Reference: 1053, 1075, and 1145 March Road – CU Developments Inc.
Geometric Road Design Drawing
Our File No.: 116132

A Geometric Road Design (GRD) letter, dated April 2021, and Comment Response letter, dated May 2022, were submitted to the City as part of the detailed subdivision engineering application. Following the latest engineering submission, modifications to the roadway geometry have resulted in a need for revisions to the GRD Drawings. This letter has been prepared to summarize the proposed changes to the roadway geometry and includes revised GRD Drawings.

Attachment 1: GRDD Drawings

PROJECT No.	116132-00
REV	REV # 3
DRAWING No.	116132-GRDD05

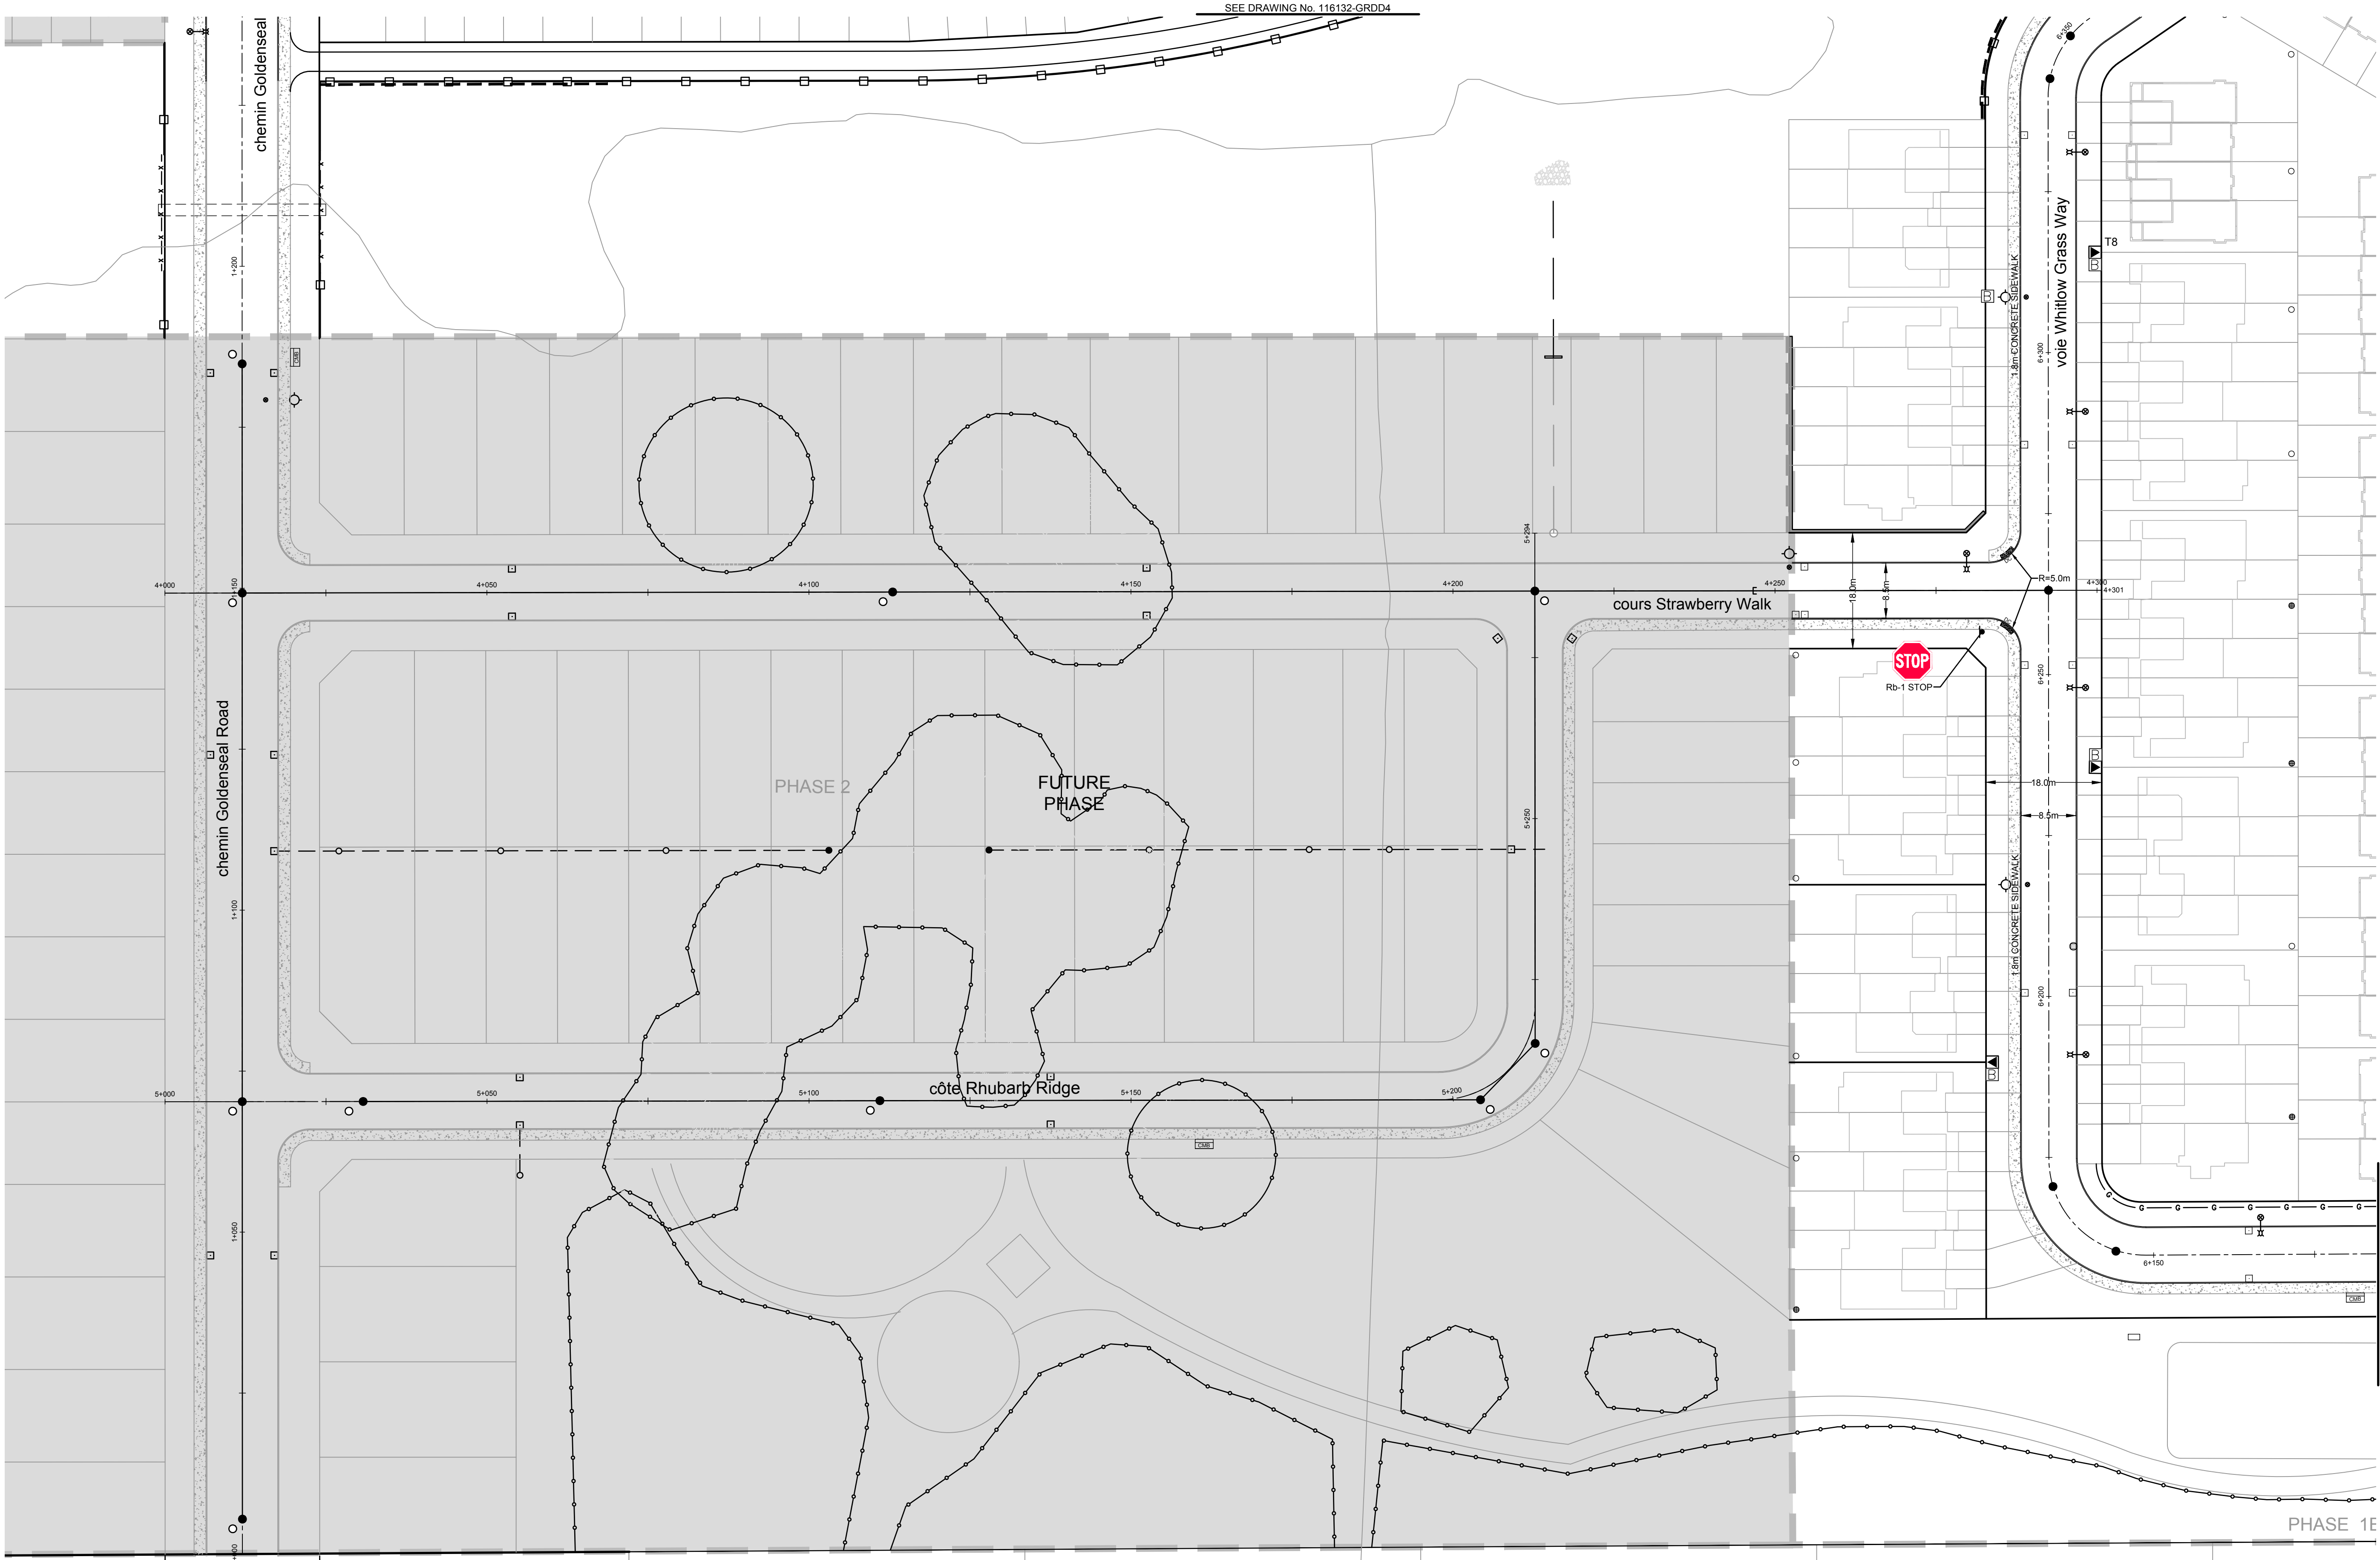
Salinger Street/Bosch Place Intersection

As the timing for the extension of Bosch Place between Salinger Street and March Road is not known at this time, this intersection will initially be constructed as a T-intersection with free flow conditions on Salinger Street. Without the extension of Bosch Place to March Road and since a sidewalk is provided on the west side of Salinger Street, an east-west pedestrian crossover is no longer proposed at this intersection.

The Bosch Place extension to March Road will be constructed as part of the 1015 March Road development. The future detailed engineering submission will modify the intersection to include a fourth leg and will review the need for east-west pedestrian connectivity at this location.
